LORSON RANCH EAST FILING NO. 1

STREET, STORM SEWER, AND POND CONSTRUCTION PLANS

SHEET NUMBER
C0.1

LORSON RANCH EAST FILING NO. 1
FULL SPECTRUM POND C5
OUTLET STRUCTURE

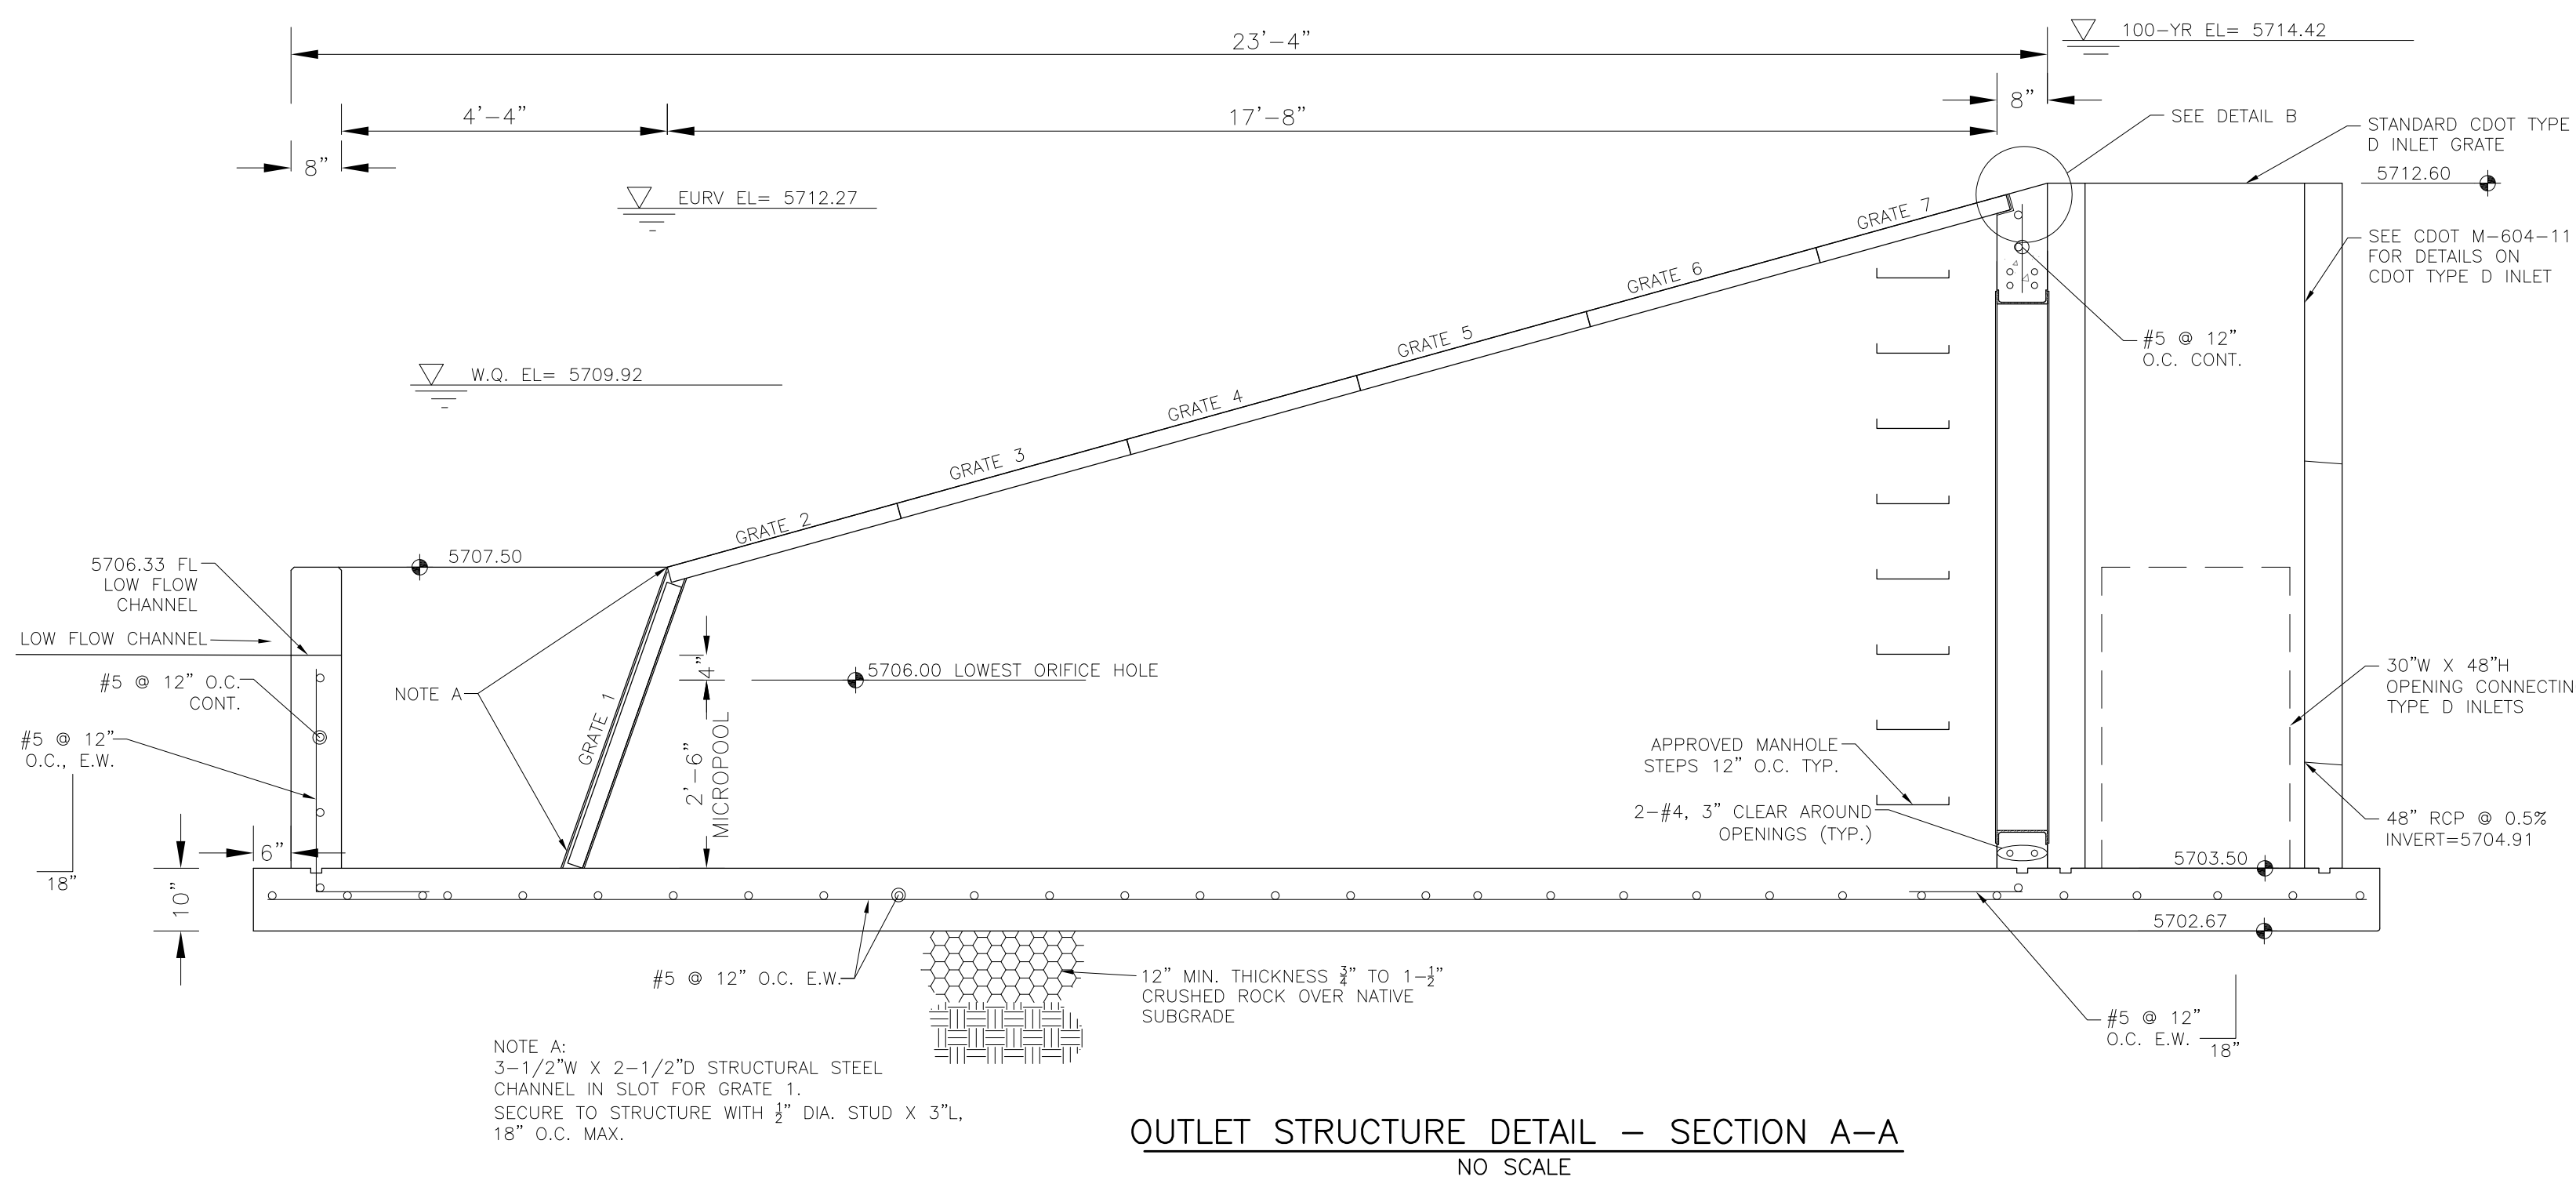
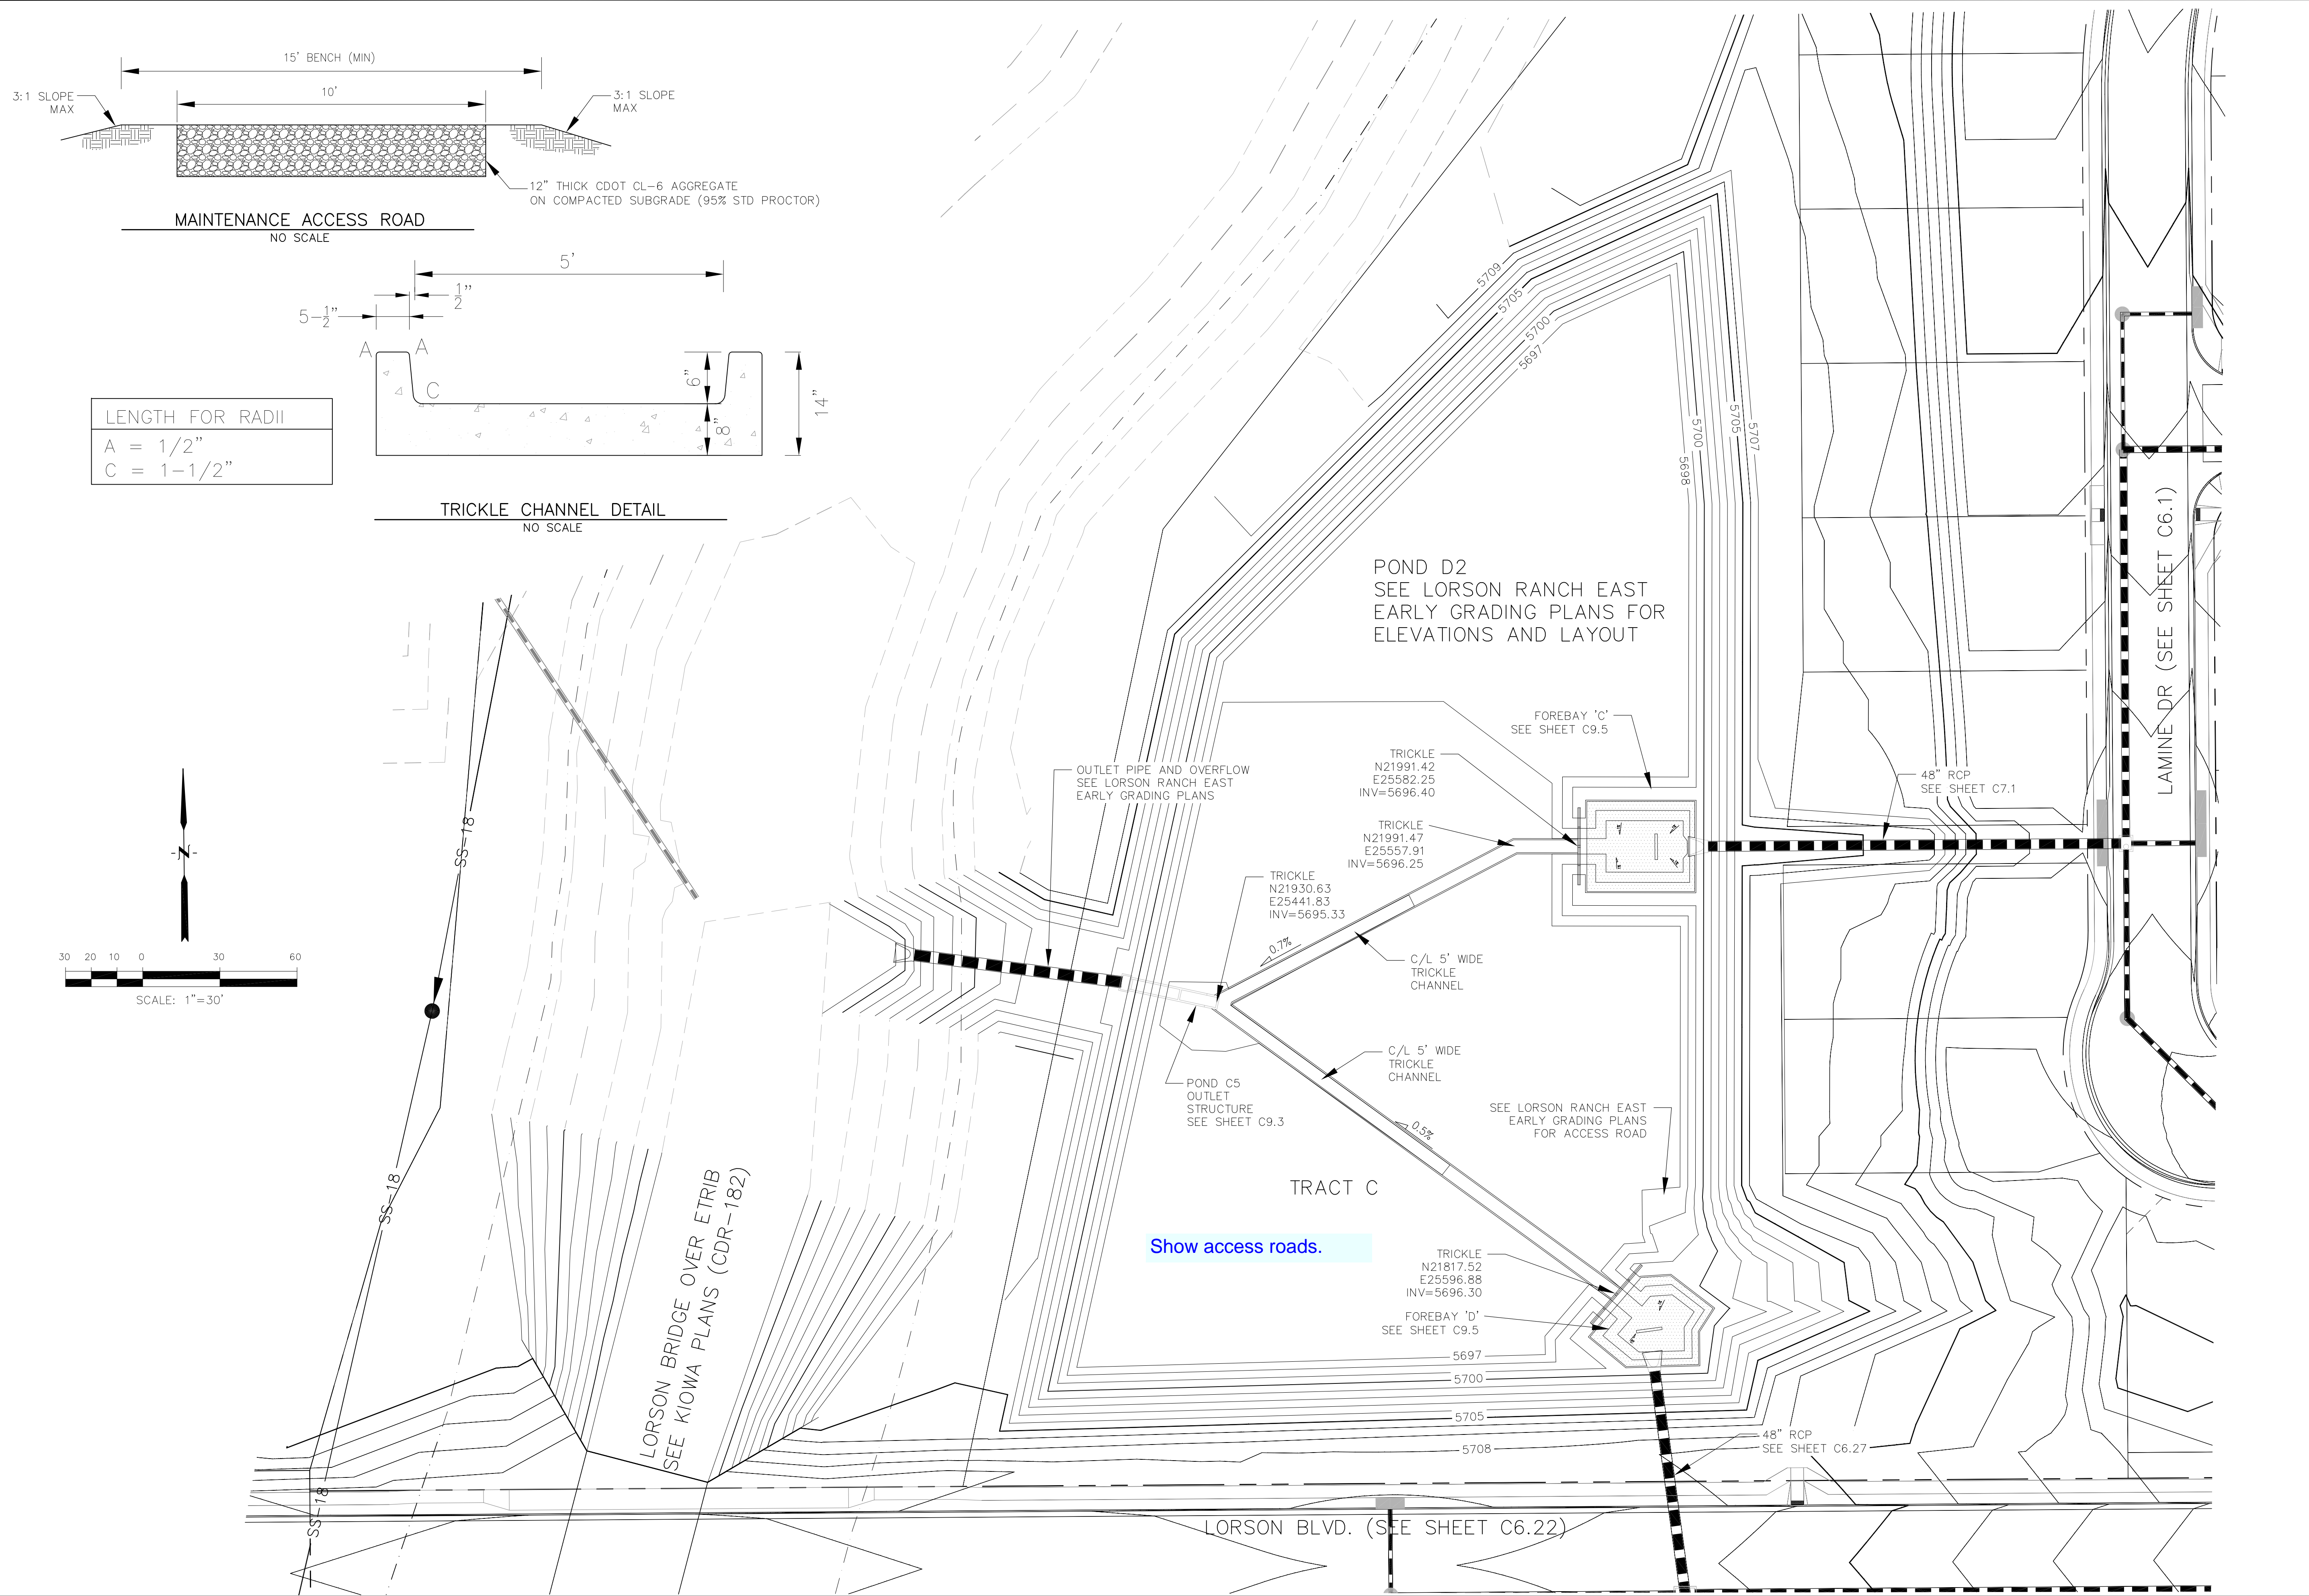
Show bolting pattern
